Department of Toxic Substances Control

December 20, 2012

**RESPONSES TO COMMENTS ON
THE DRAFT HAZARDOUS WASTE FACILITY PERMIT FOR
CLEANTECH ENVIRONMENTAL, INC.
5820 MARTIN ROAD
IRWINDALE, CALIFORNIA 91706**

Figure 2. The SFD Recreational Area with 5820 Martin Road, Irwindale, CA indicated with the flag marked “1.” Source: Yahoo! Maps.

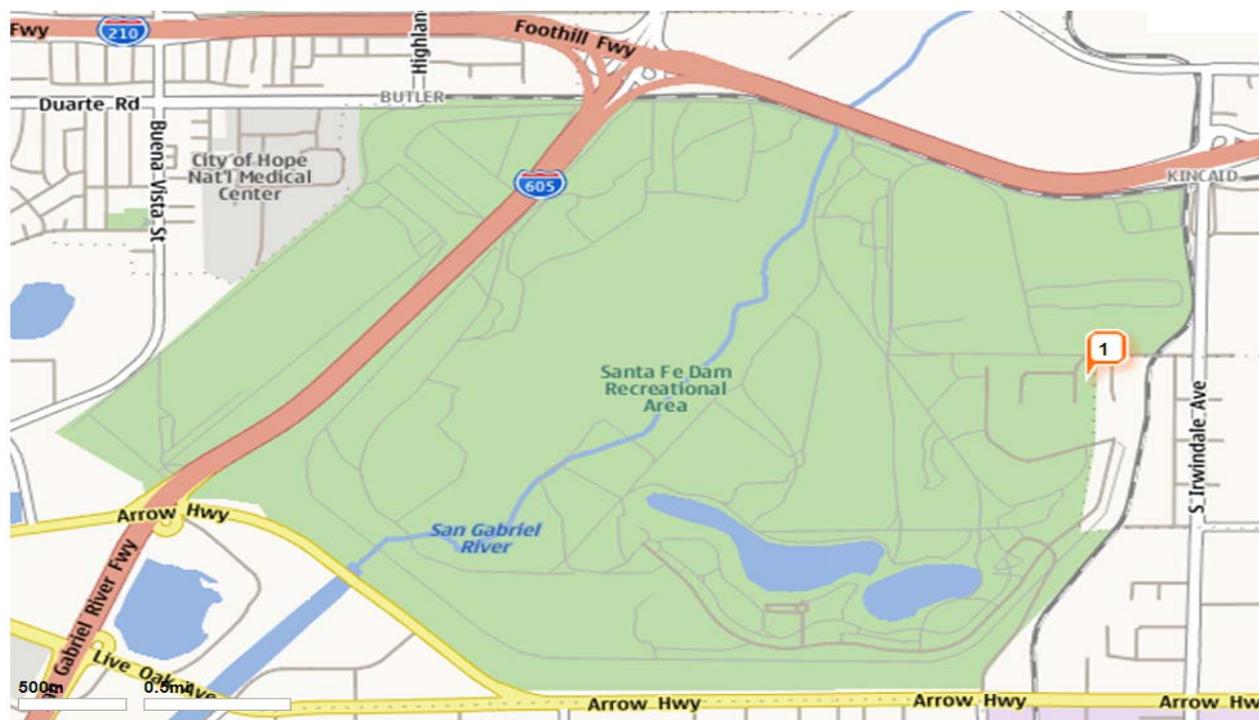
As Figure 2 demonstrates, the proposed Project is literally next door to the SFD Recreational Area. Approval of the Project without proper analysis and mitigation endangers this invaluable natural and community resource. Children playing in the water, families picnicking under the trees, friends on fishing trips, and the protected wildlife all will be only about 1,000 feet from a hazardous waste facility that stores and chemically treats used oil, oil contaminated soil, and other hazardous substances.

Not only would a spill emanating from a truck on its way to/from the proposed Project impact the sensitive, natural habitat of protected and rare species, it would also affect water quality and sensitive receptors. As demonstrated in Figure 2, the San Gabriel River is very near the proposed Project location, and trucks approaching the site will either cross the river, or pass next to it. A spill into the San Gabriel River would have very detrimental effects on the water quality of the river, both in the vicinity of the spill, and downstream of the spill. Additionally, because the facility lies on the alluvial fan of the San Gabriel River, and alluvial fans are characterized by porous sands and gravels, there is a strong possibility that a spill could quickly impact groundwater resources. These impacts would be significant, and they have not yet been analyzed.

The red flag is the CleanTech Env. Inc. facility. It is below the 210 freeway, just east and south of the San Gabriel Aquifer Spreading grounds. The Santa Fe Dam is an Army Corps of Engineers' facility on the San Gabriel River built to protect the down river communities from floods.

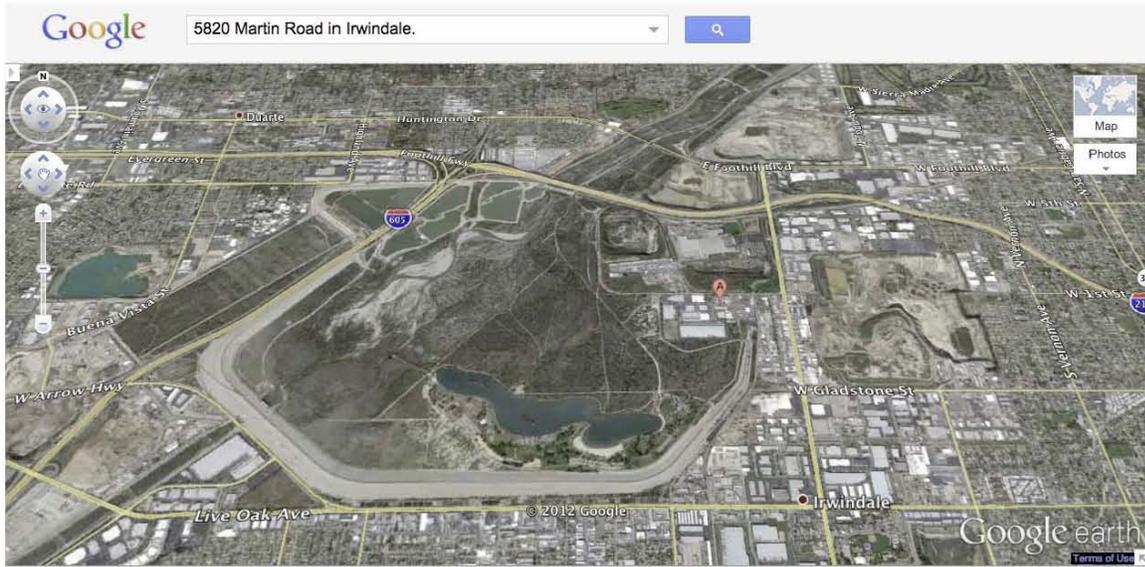
CleanTech Environmental Inc. has submitted a request for a permit for their facility at 5820 Martin Road in Irwindale. CleanTech Env. Inc (aka AgriTech International Limited,UK) wishes to collect used oil from offsite “generators” and consolidate (store) the used oil in tanks at the facility within the Santa Fe Dam. CleanTech will remove metals from the used oil and then store and enhance (dehydrate) the used oil for reuse. It will also collect waste antifreeze (poisonous to all life), oily rags, cat litter from other spills, and non-RCRA (this means; does not ignite, or is corrosive, reactive or toxic and is not a listed hazardous waste) and store them on their facility in Irwindale above the Santa Fe Dam and the Aquifer’s spreading grounds. Then the drums will be shipped offsite in trucks.

CleanTech Env. Inc. LLC. wishes to conduct business of their hazardous waste facility on soils that are the alluvial sands of the San Gabriel River above the Santa Fe Dam and near the spreading grounds for the San Gabriel Valley Aquifer, which supplies drinking water to several million people within the San Gabriel Valley. Waters in the aquifer flow downhill, or south west to the Pacific Ocean. The CleanTech Env. Inc. facility will be located within the alluvial fan of the San Gabriel River (Google Topography, the red flag is the CleanTech Env. Proposed facility) such that that oil mixes from CleanTech and the San Gabriel Aquifer, located together at the top north east section of the San Gabriel River Aquifer, will potentially mix and flow into the subsurface water body.

The spreading grounds are around the Google marker for the 605 Freeway.

The Facility is required to have a contingency plan and emergency procedures in place to respond to fires, explosions, or any unplanned sudden or non-sudden release of hazardous waste or hazardous waste constituents to air, soil, or surface water.
